Mallard Pass Action Group

15th February 2024

Mallard Pass Solar Plant NSIP application

Essendine Historic church flooded again by the river deluge from Carlby.

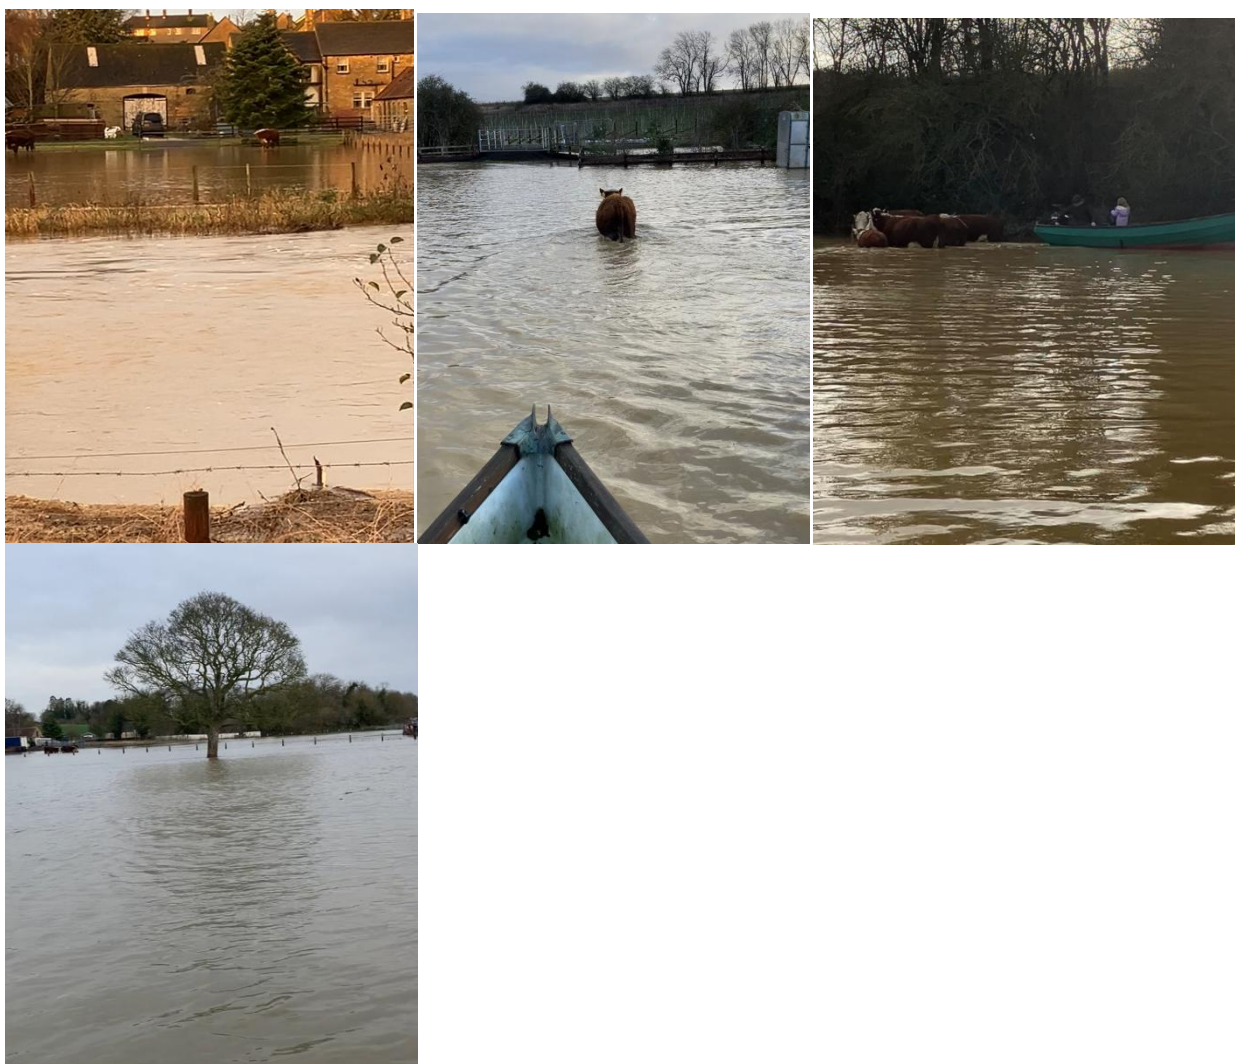
The graveyard was completely submerged; 3 ft of water in the church, worst damage on record; organ needs repairing; the pulpit was washed into the Nave and damaged; all alter linen and service books were damaged; a recent grave was underwater.

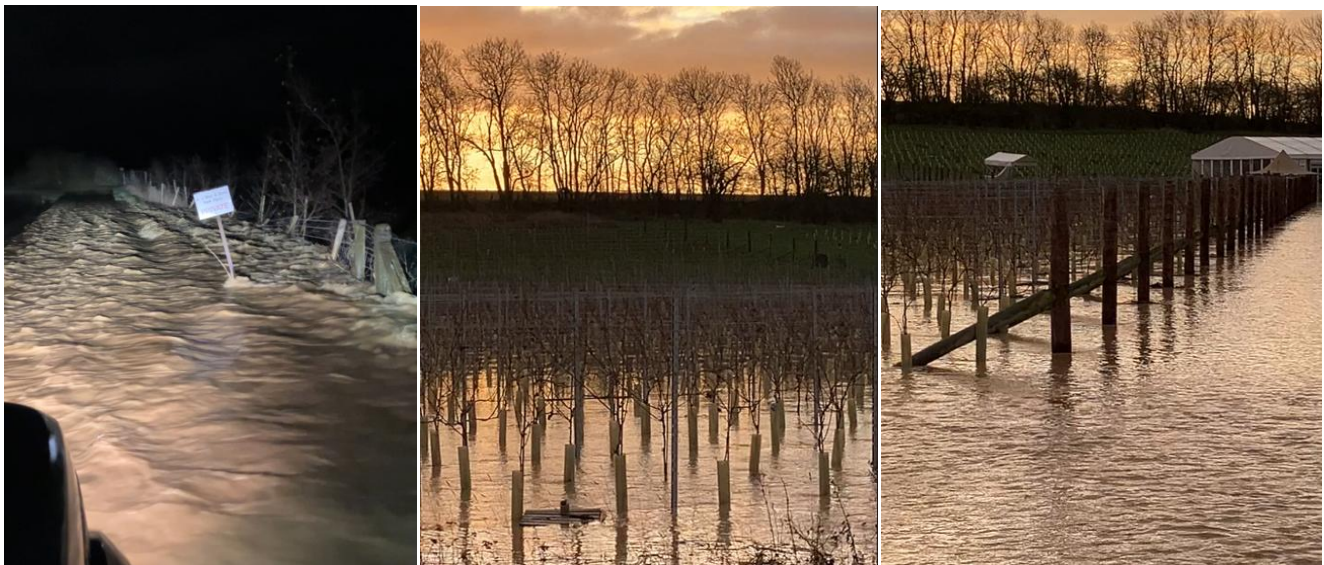
In theory this area had their 1 in 100 chance of flooding this badly in 2019, It is only 2024 and the solar plant application is proposed to last 60 years.

Farmland under water, cattle nearly submerged. Mallard Pass site just above old railway embankment

Marque business afloat

Mallard Point vineyard entrance a running river (white foam)

Anglian water pump station 5ft under water, sewage overflowing onto farm premises.
